Docket UE-141170 (Electric) and UG-141169 (Gas)

To: Washington Utilities and Transportation Commission

**RE: Sierra Club Comments on 2015 Integrated Resource Plan**

Figure 6-20: Projected CO<sub>2</sub> Emissions by Portfolio – 2015 Optimal Planning Standard

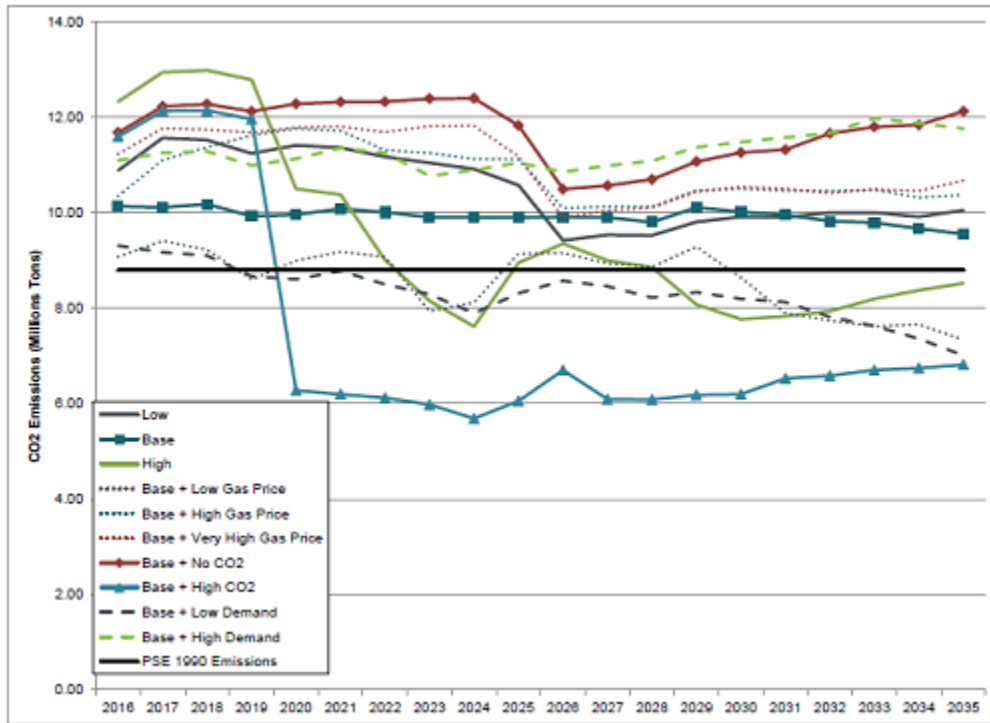
PSE needs to provide a clear vision of how they will comply. Instead we’re left with the rather unsettling Figures 6-20 and the even more bleak 6-21:

These figures clearly illustrate we need drastic action to reduce CO<sub>2</sub> emissions, such as retiring coal and some natural gas plants. PSE does not produce the results that curb and reduce carbon emissions, nor to ensure worldwide temperature increases are constrained to 1.5 or 2 degrees Celsius.
